Show 2010 ADA Standards compliance with section 36.401 New Construction.

DONAGHY / VERILLA
ADDITION PROPOSAL
1208 WASHINGTON AVE.
PORTLAND
 1/4" = 1'-0"

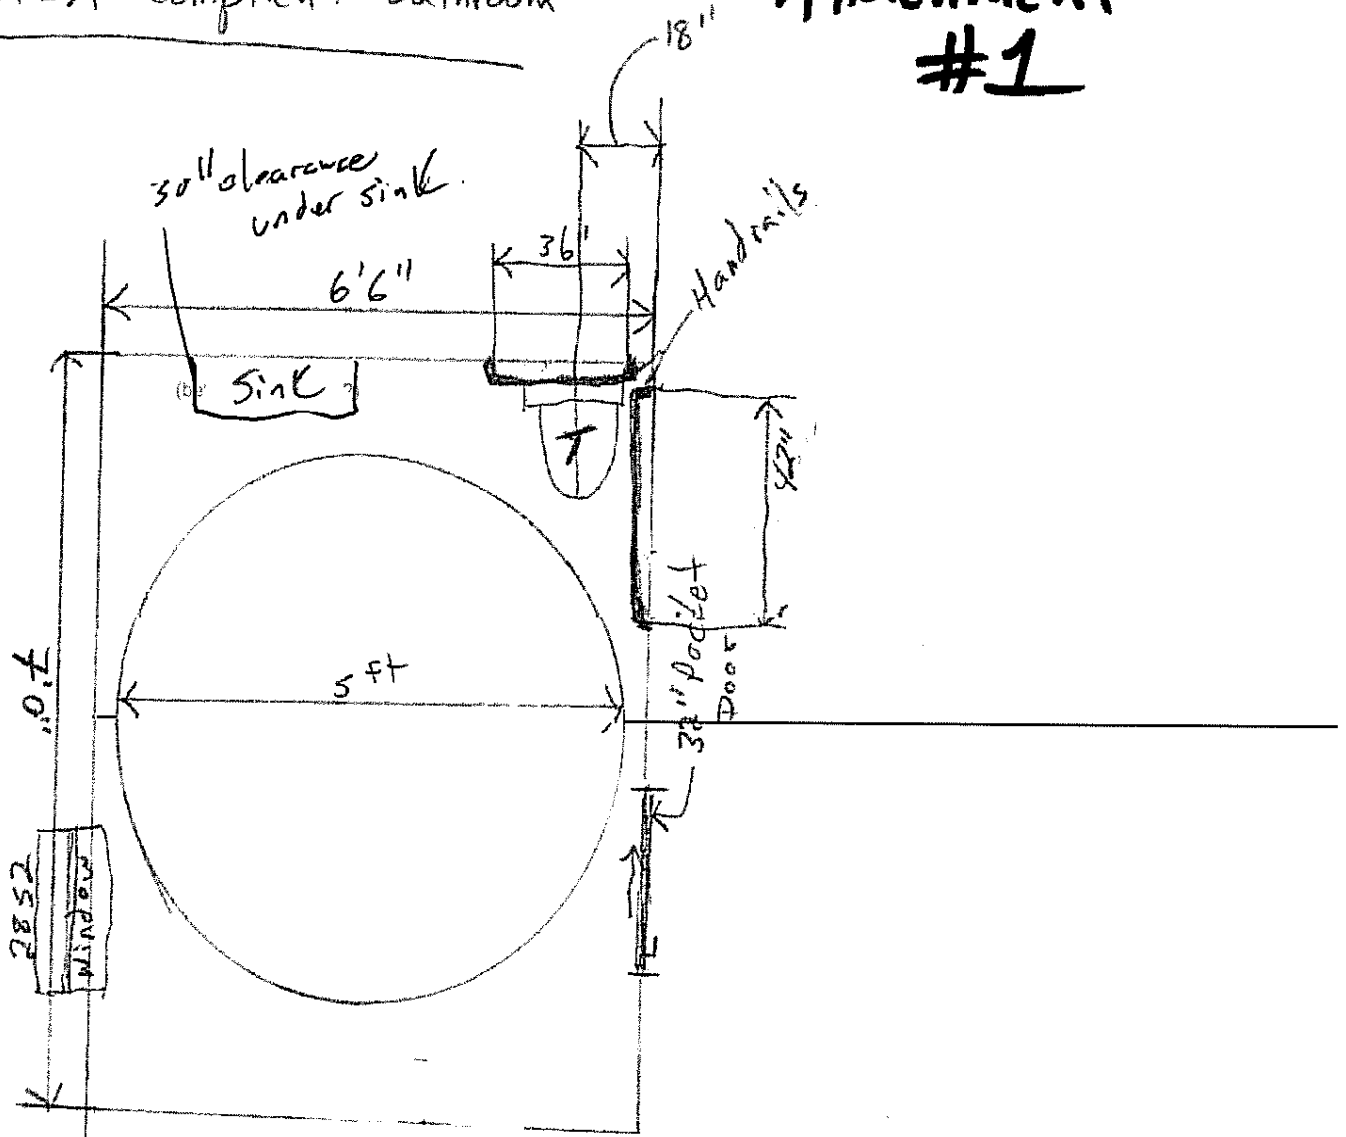
Please provide a section view drawing with the following information:
 Footing dimensions and depth below grade.
 Foundation damp proofing and drainage.
 Crawl space venting sizes/locations.
 Anchor bolt size and spacing.
 Joist, stud and rafter spacing.
 Framing connections and fastener schedule.
 Sheathing (floor, roof, wall) span ratings and thicknesses.

Please provide the following information on current drawings:
 Door/window header sizes/spans and number of jack studs.
 Insulation R-values for foundation, floor, walls and roof.
 Door/window U-values.
 Safety glazing locations.
 Stair riser and tread dimensions.
 Handrail locations and heights.

2 by 10 floor joists
framed 16 on center
no hangers needed as joists will be sitting on 2 by 6 pressure treated plate which sits on sill seal
and all lagged to foundation
2 by 10 blocking down the middle of floor joists
r 30 insulation *Faced*
5/4 advanced for floor sheathing gable and main
1 inch thermax on underside of floor joists for vapor barrier.

2 by 6 framed with one bottom plate and 2 top plates with a total height of 8 feet
windows and doors will have 2 by 8 headers, 3 2 by 8's with 1/2 inch plywood in between
Any opening greater than 4 feet will have double jacks and anything under 4 feet headers will have one jack stud
7/16 osb for wall sheathing.
house wrap on entire structure
r 21 insulation in walls Please specify insulation type *Faced*

2 by 10 rafters
framed 16 on center with 2 by 6 collar tie creation flat ceiling with hurricane plate fastened from rafters with 1/2" x 4"
Proper vent in between rafters for soffit ventilation

will have 2 pt stringers
6 1/2 rise
11 inch thread
42 inches wide
Railings
36 inches high
ballister spacing at 3.5 inches apart
1 graspable hand rail on both side of stairs
10 inch thread

The bathroom window will have safety and glazing glass.
u values are normal standard u values for maine codes

Foundation

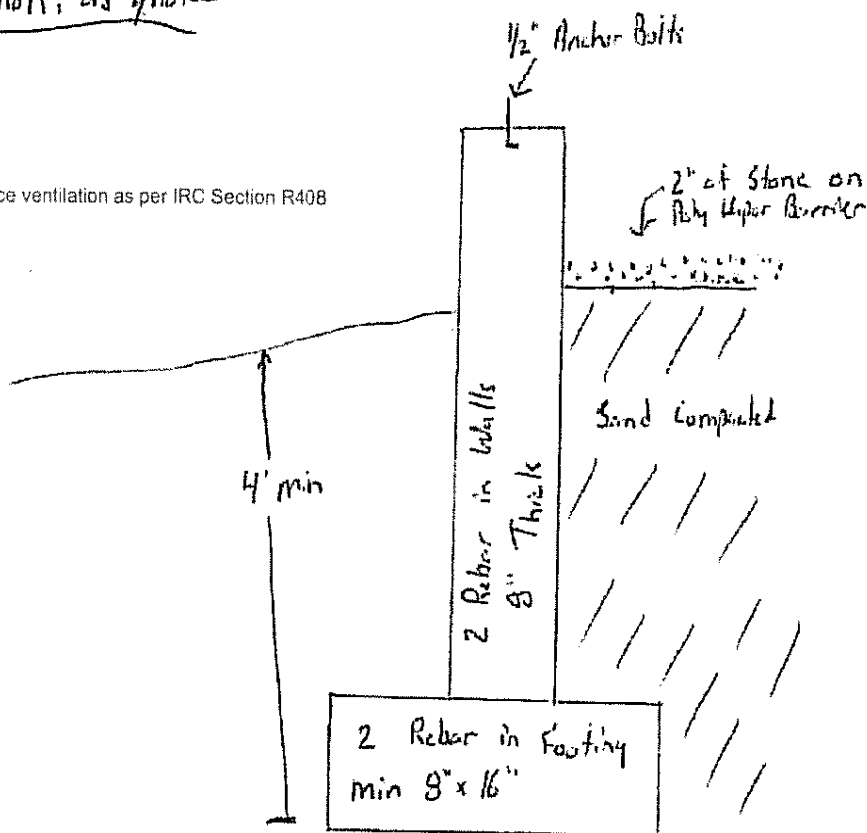
Show under floor space ventilation as per IRC Section R408

Show under floor space ventilation as per IRC Section R408

No insulation, as quoted

2x3 Vent

Vented
 into
 Existing
 Foundation

Footing dimensions and depth below grade. Minimum footing dimensions will be 8"x16". 4' minimum depth.

Foundation damp proofing and drainage. I don't have any included in my price. I figured the inside being back filled higher than the outside grade so this wouldn't be required. (see my attached sketch)

Crawl space venting sizes/locations. All research now shows that venting crawl spaces causes more moisture when you let the outside air in.

The thought process now, and what people are doing is creating an opening between the existing foundation and the crawl space. This allows your the crawl space to be conditioned to the same level as the basement, and also provides an access point. WE ALREADY HAVE A 2 X 3 OPENING THAT WILL BE BETWEEN CRAWL SPACE AND EXISTING FOUNDATION WHERE A PREVIOUS BASEMENT WINDOW WAS

Anchor bolt size and spacing. 1/2" anchor bolts spaced every 6'.

2x3 vent through Foundation wall
(Replaces existing basement window)
